**Sent:** 24/10/2019 10:42:46 AM  
**Subject:** submission to DA 2019/1118 - 51 Amourin Street North Manly  
**Attachments:** 51 Amourin St - submission.pdf;

**Submission in regards to Development Application  
DA/2019/1118 – 51 Amourin Street North Manly**

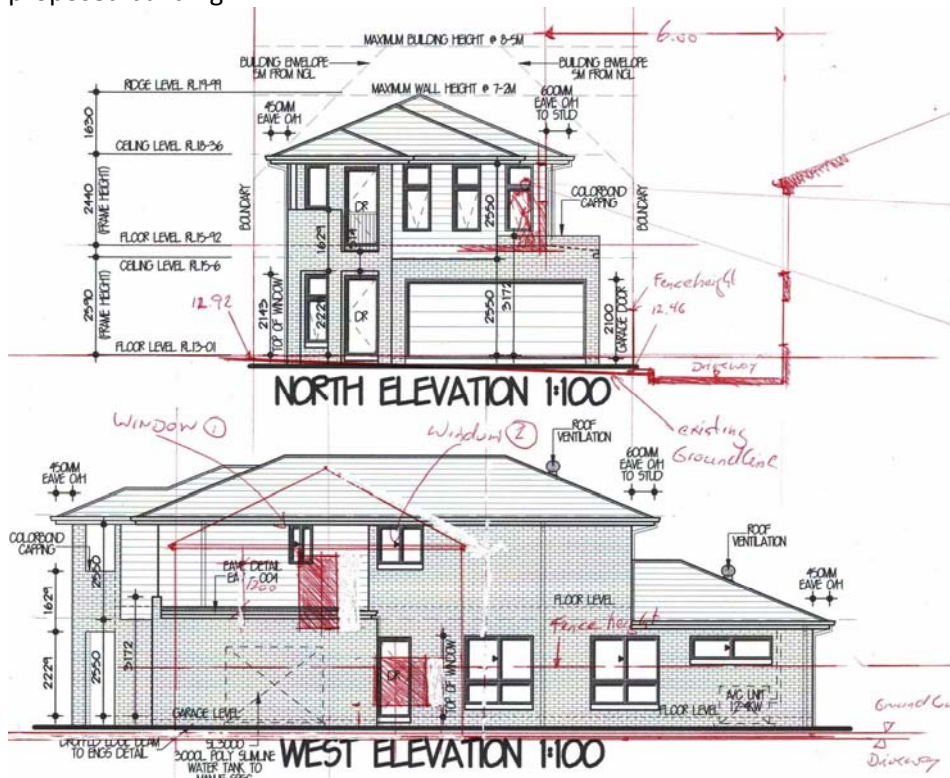
2. The attached sketch below indicates the locations of our windows in relation to the proposed building.

- a. From our conversation I understand that the marked Window 1 (First Floor on West Elevation) is a Bathroom window. In my understanding this window should be obscure to provide sufficient privacy

- b. From our conversation I understand that the marked Window 2 (First Floor on West Elevation) is a Bedroom window. It is unreasonable to ask for obscure glass in a Bedroom, but I would like to ensure that sufficient steps are taken to avoid overlooking into our property (esp. towards our windows).
